**January 31, 2022**

**RE: Valero Feedback on the Low Emission Diesel (LED) Study: Biodiesel and Renewable Diesel Emissions in Legacy and New Technology Diesel Engines**

Figure 1: Breakdown of Diesel HDV Registration in California by Model Year

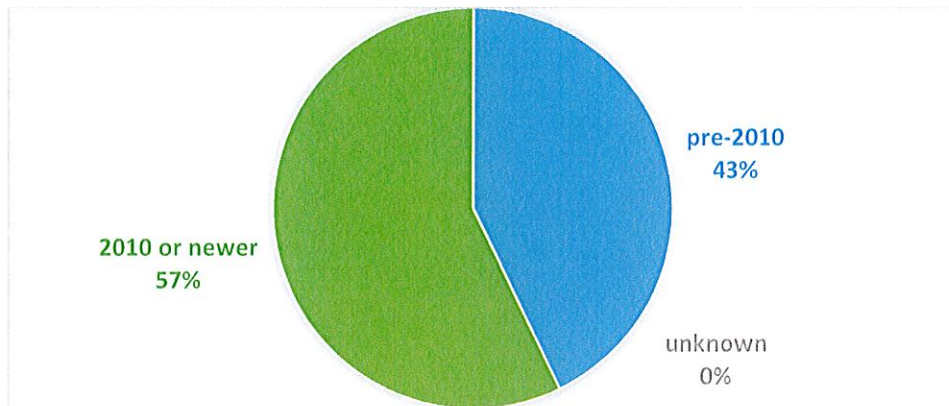
conventional diesel.<sup>1</sup> The observation is consistent with results presented to the Bay Area Air Quality Management District (BAAQMD) and South Coast AQMD (SCAQMD) in 2017 for legacy on-road and off-road diesel Heavy-Duty Vehicles (HDV).<sup>2</sup> The improved NOx performance in legacy HDV is notable, given that 43% of the diesel HDV registered in California are of pre-2010 Model Years and are not likely to be factory-equipped with advanced NOx emission controls such as SCR.<sup>3</sup>
